UNITED STATES PATENT AND TRADEMARK OFFICE

APPLICATION NO.	FILING DATE	FIRST NAMED INVENTOR	ATTORNEY DOCKET NO.	CONFIRMATION NO.
10/562,894	12/29/2005	Stefan Marcus Verbrugh	NL 030678	6922
24737 7590 03/21/2007 PHILIPS INTELLECTUAL PROPERTY & STANDARDS P.O. BOX 3001 BRIARCLIFF MANOR, NY 10510			EXAMINER LOVELL, LEAH S	
			ART UNIT 2885	PAPER NUMBER
SHORTENED STATUTORY PERIOD OF RESPONSE		MAIL DATE	DELIVERY MODE	
3 MONTHS		03/21/2007	PAPER

Office Action Summary	Application No. 10/562,894	Applicant(s) VERBRUGH ET AL.	
	Examiner Leah S. Lovell	Art Unit 2885

DETAILED ACTION

FIGURE A: Optical waveguide from Figure 7 of Bucher indicating a first and second portions and the region defined as the overlapping portion.

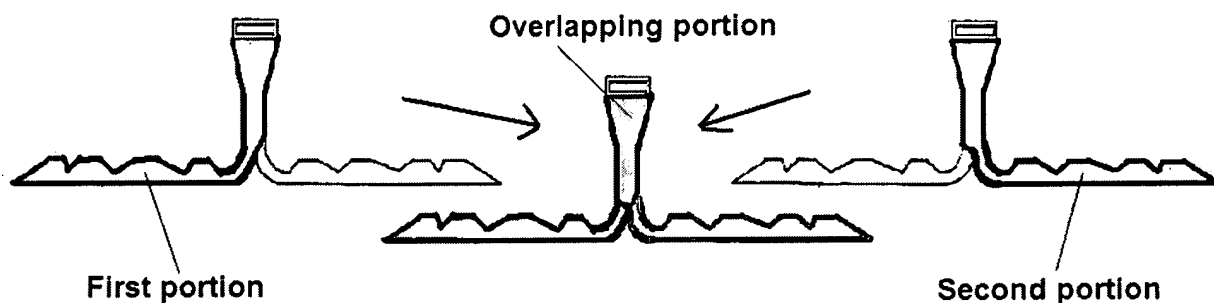
In regard to claim 18, Bucher discloses the optical waveguide comprises a first portion which overlaps a second portion at an overlapping section for coupling the light from the first portion to the second portion via the overlapping section [see figure A below].
